# Gloucester Lodge Design and Access Statement Addendum S.73 Amendment

**Date**  
July 2017

**Stage**  
Planning

This report is being submitted in support of applications for minor material amendments (S.73 of TCPA '90) and listed building consent.

## Ground floor: forecourt

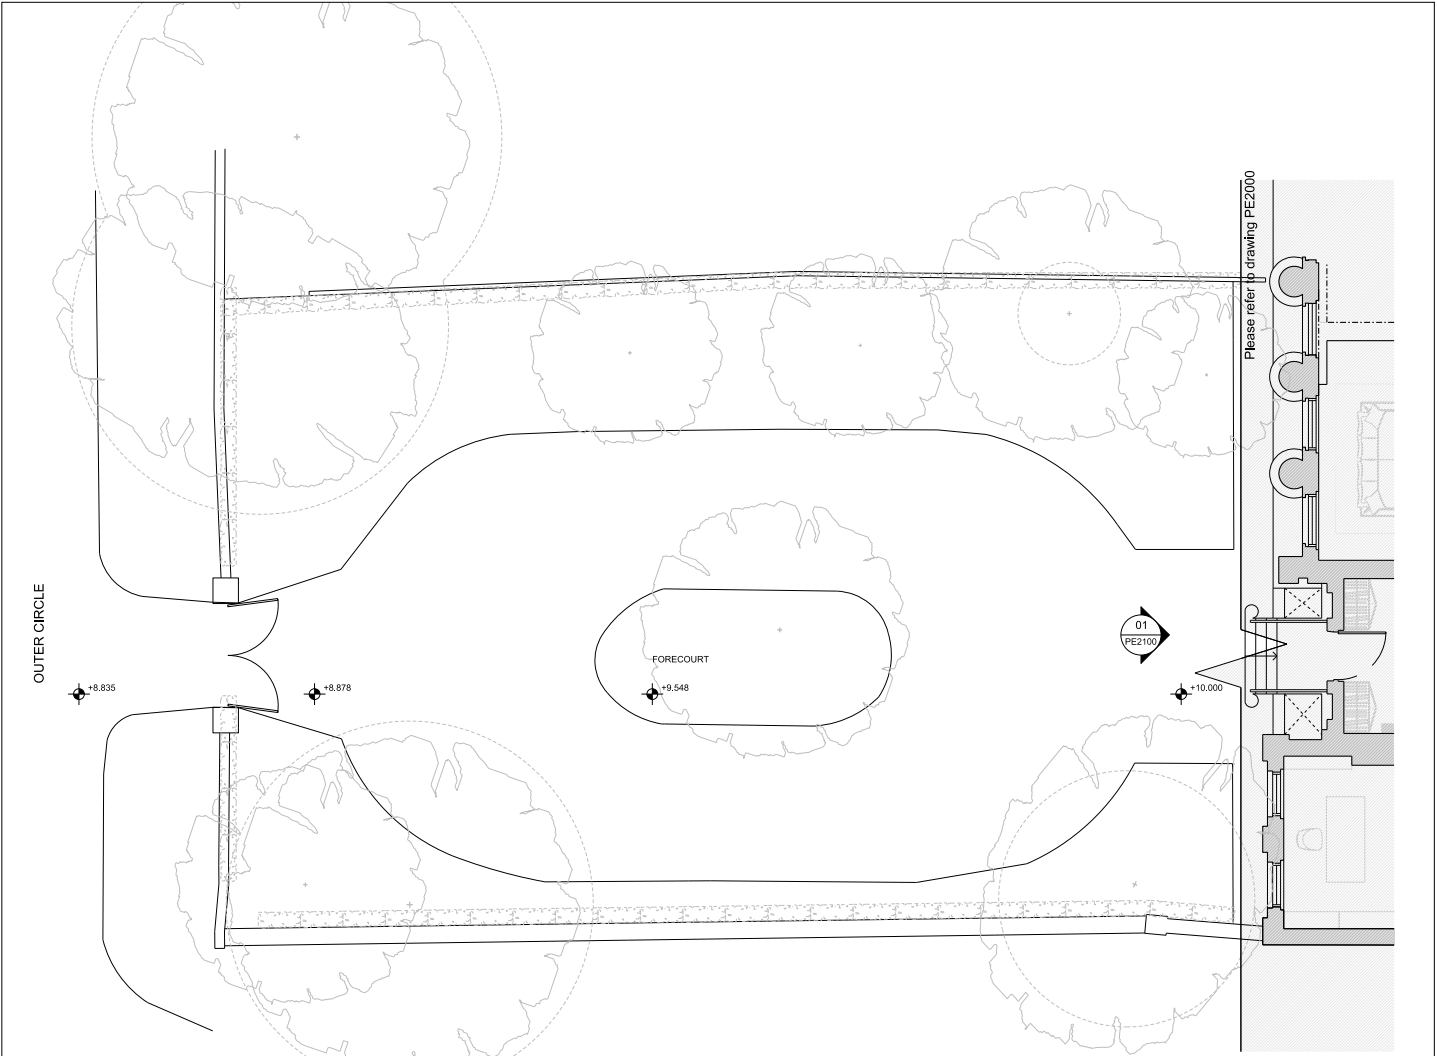
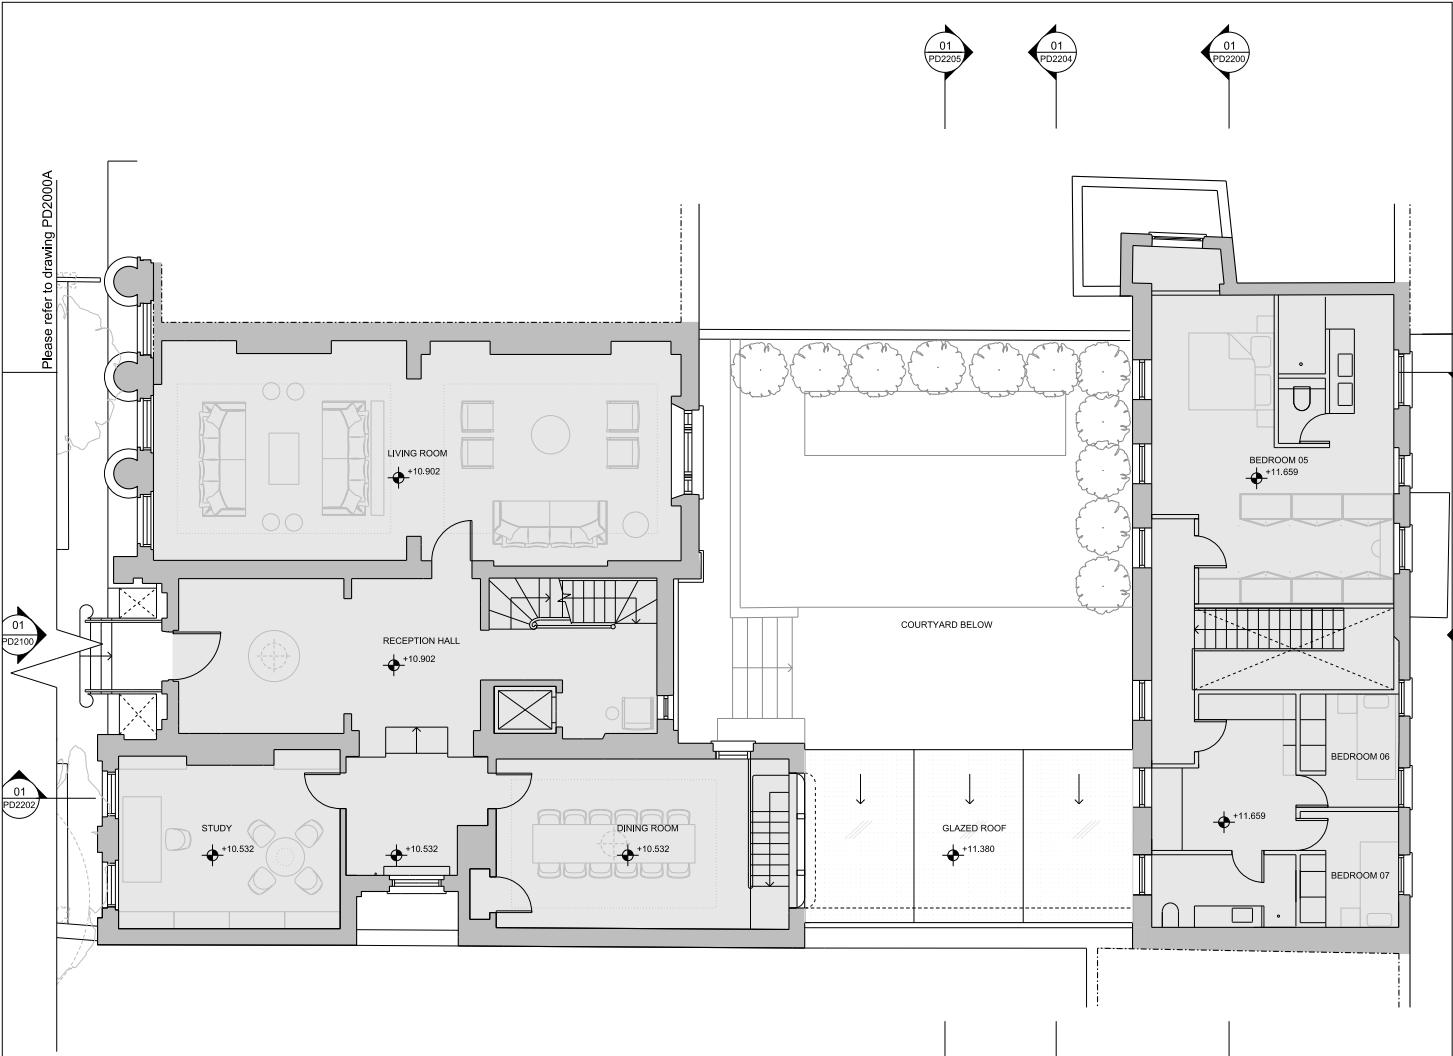
There is no proposed changes to the forecourt or the front elevation addressing Regents park

## Ground floor

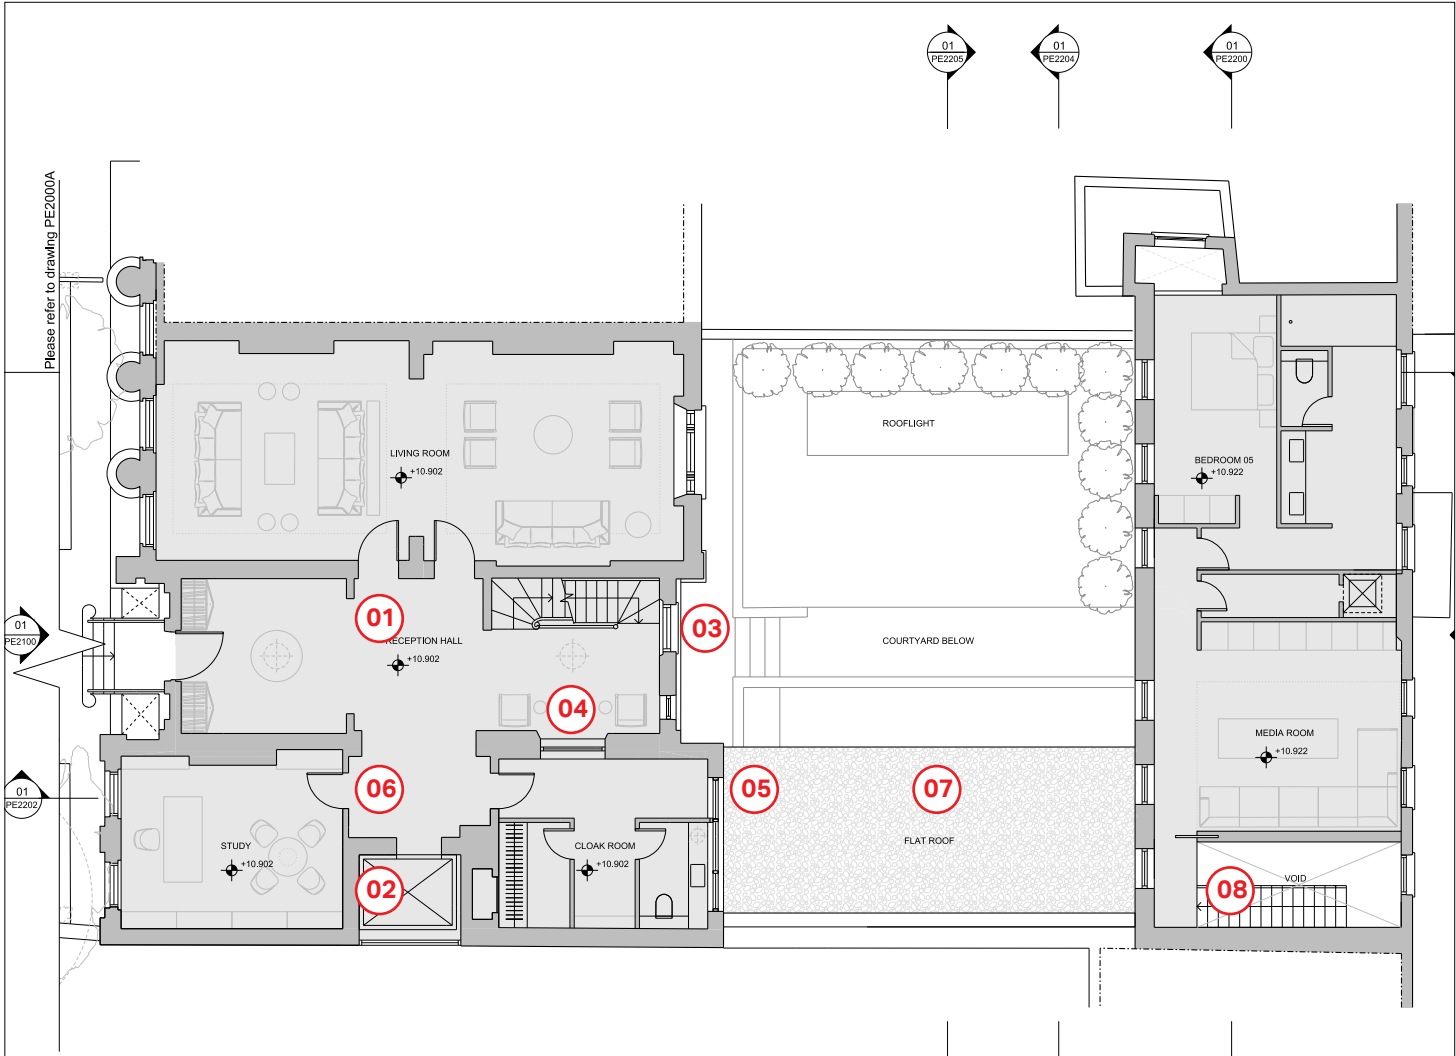
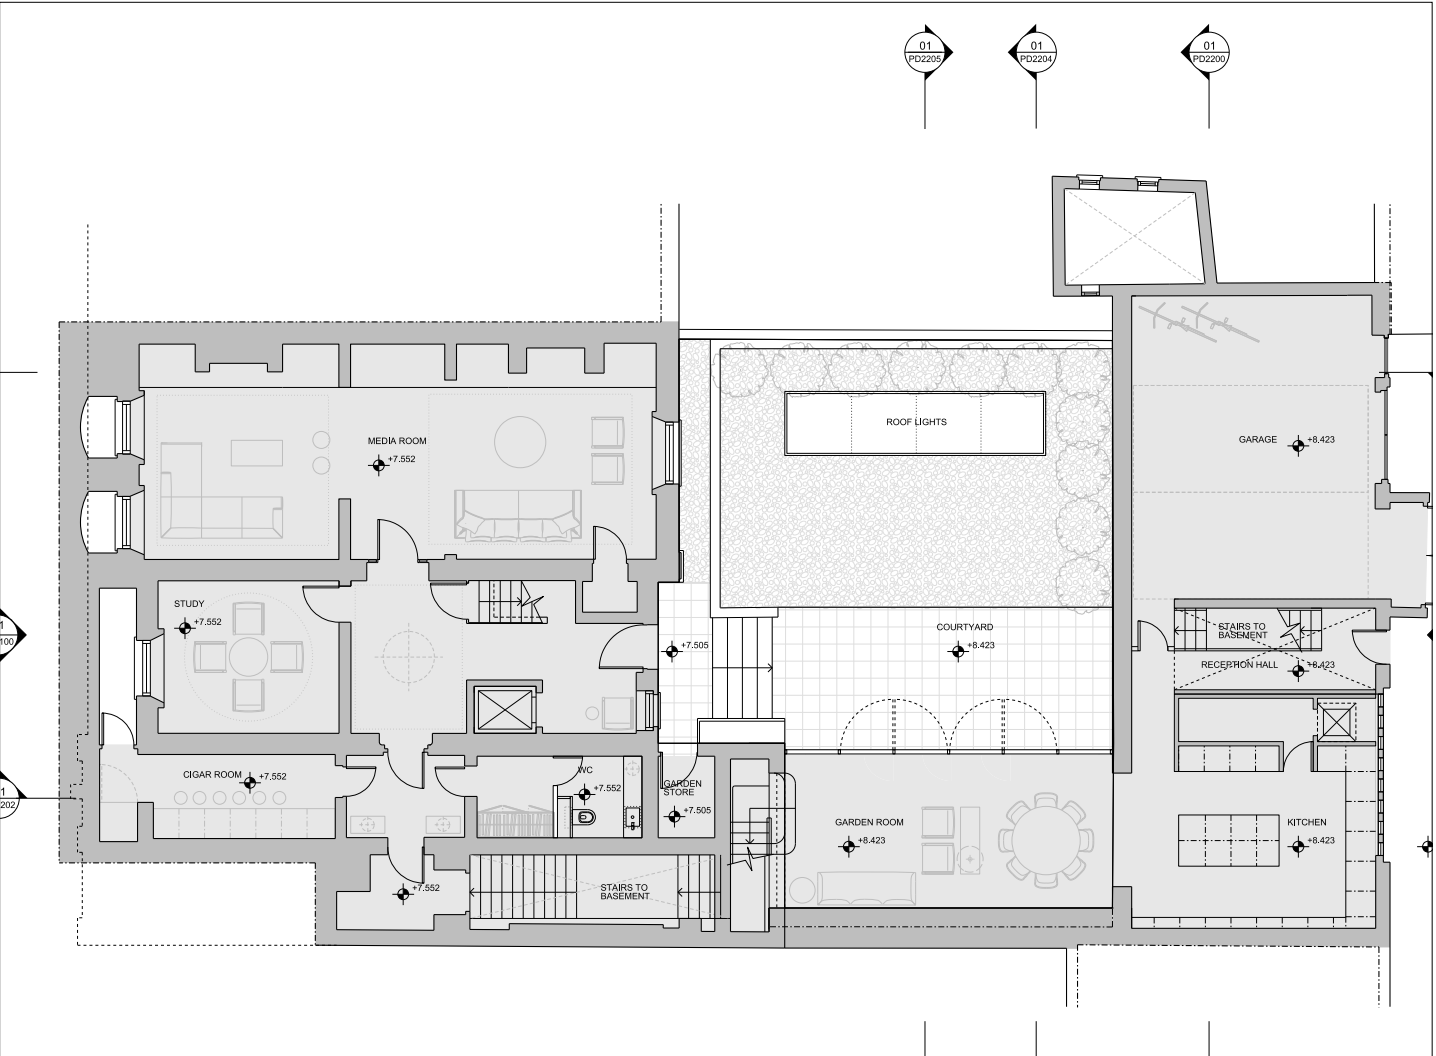
- 01 An additional door into the living room
- 02 Glass lift has been relocated into the lightwell
- 03 New window on the rear elevation aligned with the upper floor windows above
- 04 Proposed window (internal) in the position of the original 1830s layout
- 05 Removal of the C.20th protrusion on the southern wing. Elevation to re-instate window to match removed

- 06 Floor level of southern wing to match reception hall for step-free access
- 07 Link building to change from fully glazed roof to a solid roof.
- 08 New mews staircase to be relocated

## Lower ground floor

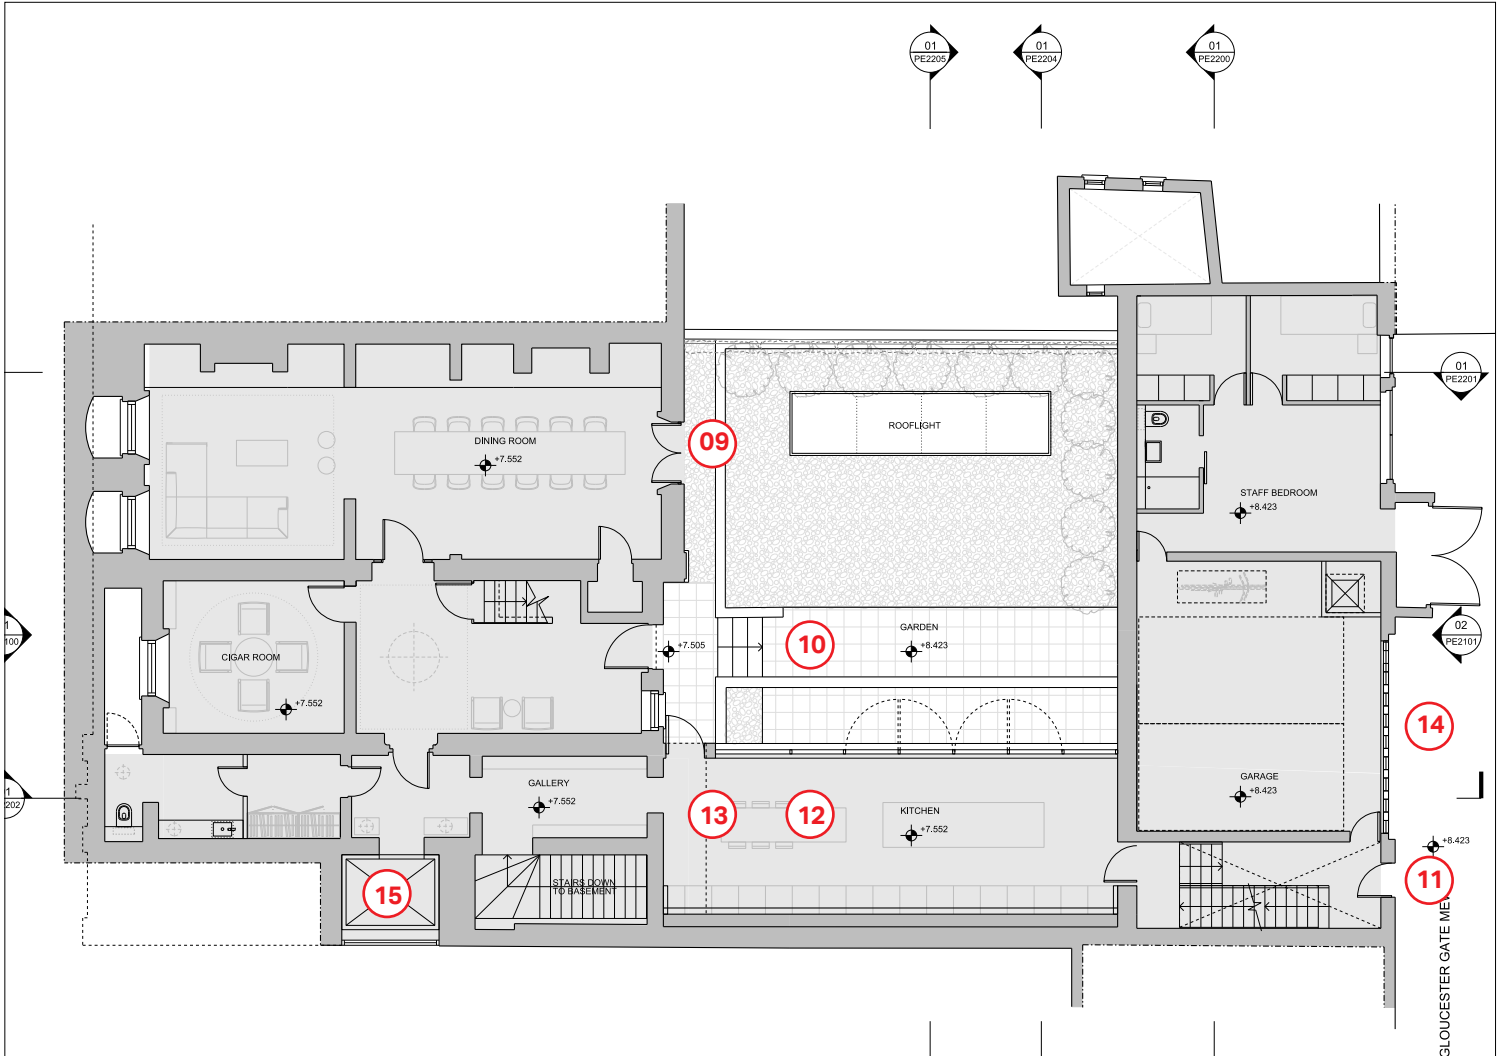
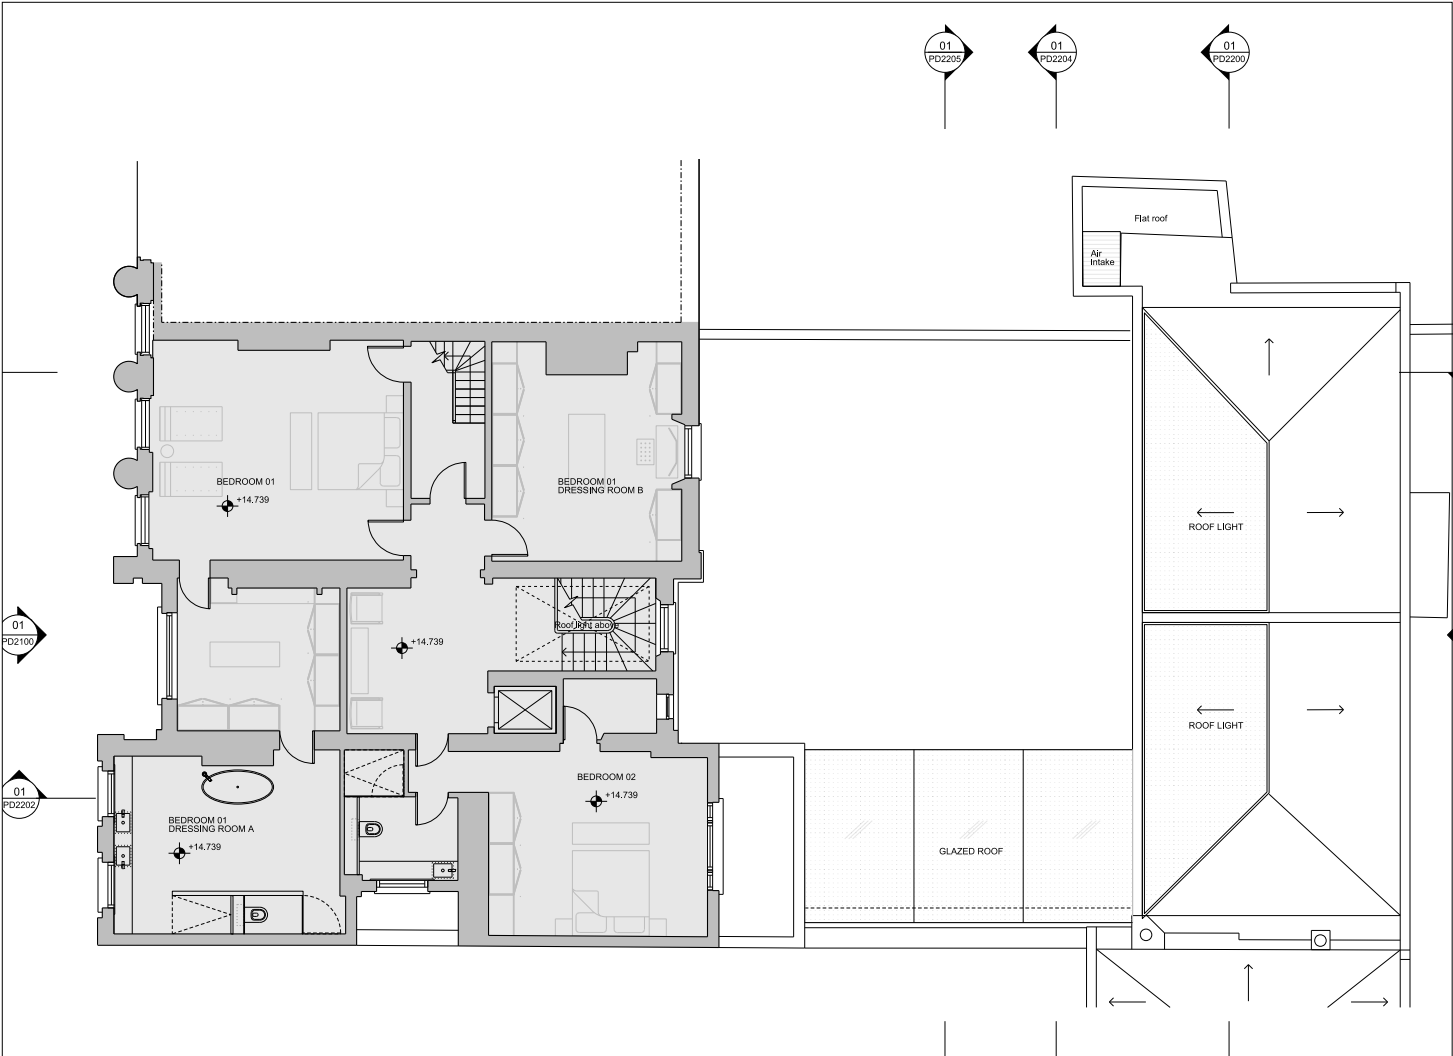
- 09 Proposed doors from the relocated dining room into the courtyard
- 10 Reduced width of the courtyard steps
- 11 Relocated mews entrance
- 12 Lowering the floor level of the link to match corresponding level of the main house
- 13 Removal of stairs from the ground floor into the link.

- 14 Garage to be relocated into No. 12 Gloucester Gate Mews. Existing garage door opening to be widened to improve vehicular access.
- 15 Lift relocated into lightwell as per ground floor. Landing of staircase to basement re-positioned to suit
